**FINAL
ENVIRONMENTAL IMPACT STATEMENT
FOR THE
GILBERTON COAL-TO-CLEAN FUELS
AND POWER PROJECT**

Volume 2: Appendices

October 2007

COVER SHEET

SUP21-2

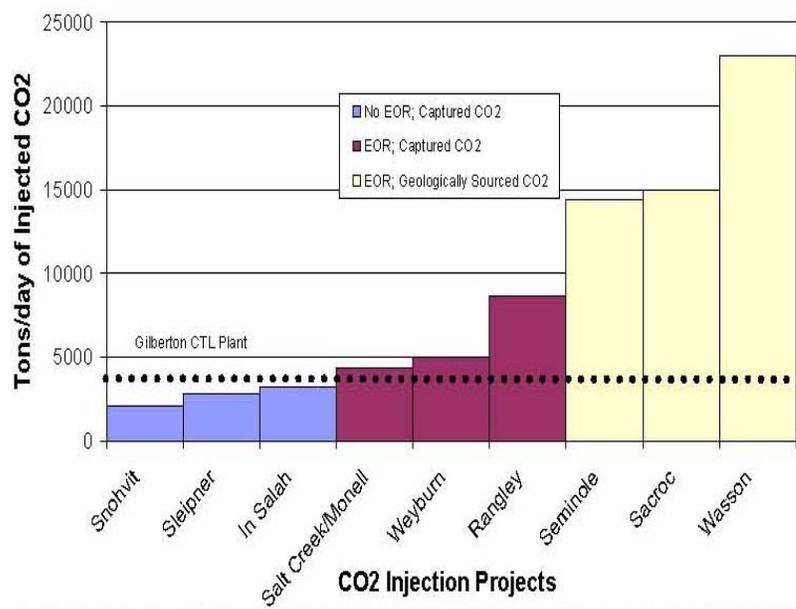
c. Thousands of CO₂ injection wells are safely and economically operating in over 70 CO₂ EOR projects in the USA and more in other countries. Thirty million tons per year of new CO₂ plus additional quantities of recycled CO₂ is injected in EOR project wells in the USA. Some CO₂ EOR projects inject at rates higher than or near the 3,973 tons per day needed for the Gilberton CTL project. See Figure below for some examples.

Industry has experience injecting CO₂ in quantities comparable to the Gilberton CTL Plant.
